# UNITED STATES PATENT AND TRADEMARK OFFICE

10/586,572

Peter Kristian Bjornsson

<b>Office Action Summary</b>	<b>Application No.</b> 10/586,572	<b>Applicant(s)</b> BJORNSSON ET AL.	
	<b>Examiner</b> Tho v. Duong	<b>Art Unit</b> 3744

Figure A: The modified figure corresponds to figure 4 with limitation shown..

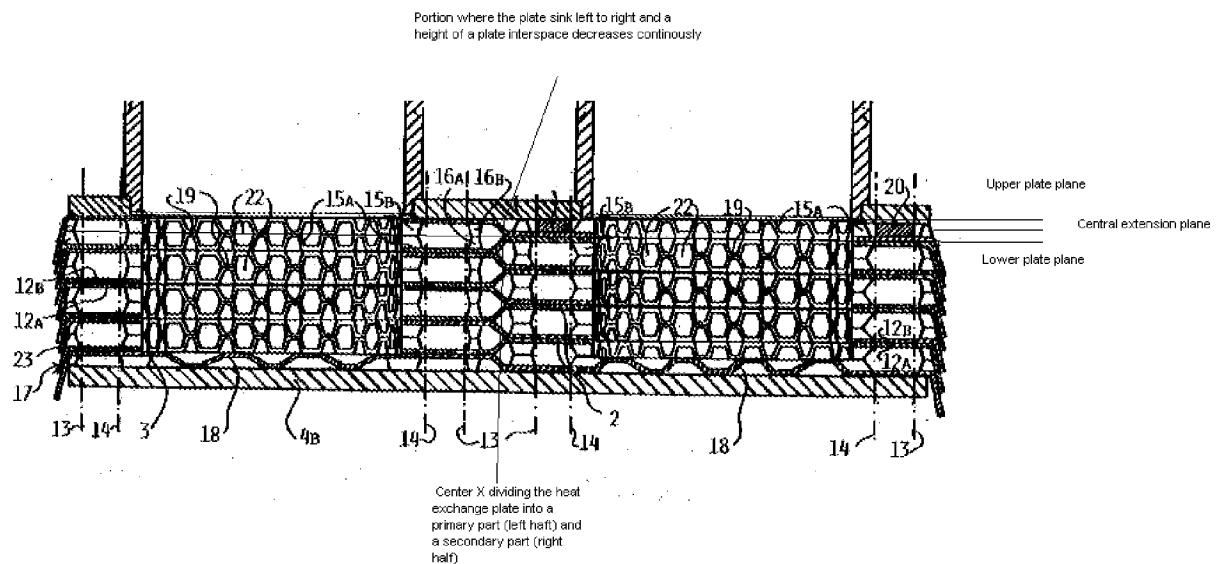
Claims 27-52 are rejected under 35 U.S.C. 102(b) as anticipated by or, in the alternative, under 35 U.S.C. 103(a) as obvious over Bergqvist et al. (US 4,987,955). Bergqvist discloses (figures 1-4 and figure A as see bellow) a plate package for a plate heat exchanger including at least two identical heat exchanger plates having a plate interspace therebetween, wherein the heat exchanger plate extends between a primary edge zone and a secondary edge zone in parallel with a central extension plane, an upper plate plane and a lower plate plane, wherein the central extension plane includes a center axis dividing the heat exchanger plate into a primary part and a secondary part, the heat exchanger plate comprising a first end area, a second end area, a central heat transfer area (9), which extends between the primary edge zone and the secondary edge zone from the first area to the second end area; a primary porthole (11a) and a secondary porthole (11b), which extend through the heat exchanger plate in the first end area and each of which is surrounded by a respective adjoining edge area, wherein the primary porthole (11a) is located on the primary part and the secondary porthole (11b) is located on the secondary part, a

distribution area which extends on the first end area and has a base surface extending from the primary porthole (11a) to the central heat transfer area, wherein the base surface is located at an upper level in the proximity of the upper plate plane in the proximity of the edge area of the primary porthole and sinks successively to a lower level in the proximity of the lower plate plane in the proximity of the secondary edge zone; the base surface sinks continuously along a border to the central heat transfer area from the upper level to the lower level and from the proximity of the primary edge zone to the proximity of the secondary edge zone; the distribution area includes a number of projections and depressions (15), and substantially each projection extends in a respective direction running from the primary port hole towards the central heat transfer area; wherein the projection (15) has a length which is substantially shorter than the distance from the primary porthole to the central heat transfer surface area along the direction of the projection. Regarding claim 35, wherein substantially each depression (depression formed between two projections 15, figure 2) extends substantially perpendicular to the direction of an adjacent projection, wherein the direction of the projection is considered to be radial direction to center of the port hole. Regarding claims 36, 37 and 39, Bergqvist discloses (column 3, lines 45-60) the heat exchanger plate is symmetrical with regard to the center axis so that substantially each depression has a shape and a position corresponding to a shape and a position of a projection on the other side of the center axis, and each depression is designed to abut a projection of an adjacent turned heat exchanger plate in the plate package. Regarding claim 28, the limitation of "compression-molding" is not germane to the issue of the patentability of the device itself. "Even though product-by-process claims are limited by and defined by the process, determination of patentability is based on the product itself. The patentability of a product does not depend on its method of production. If the product in the product-by-process claim is the same as or obvious from a product of

Regarding claims 38 and 49, applicant is reminded that the examiner must interpret the limitation as broadly as it reasonably allows, in which Bergqvist discloses (figure 2) each projection (15) and depression (between the projections) having two long sides and two ends wherein one of the ends of the projections on the secondary part extends to one of the long side of a depression and one of the ends of the depression on the primary part extends to one of the long sides of a projection.
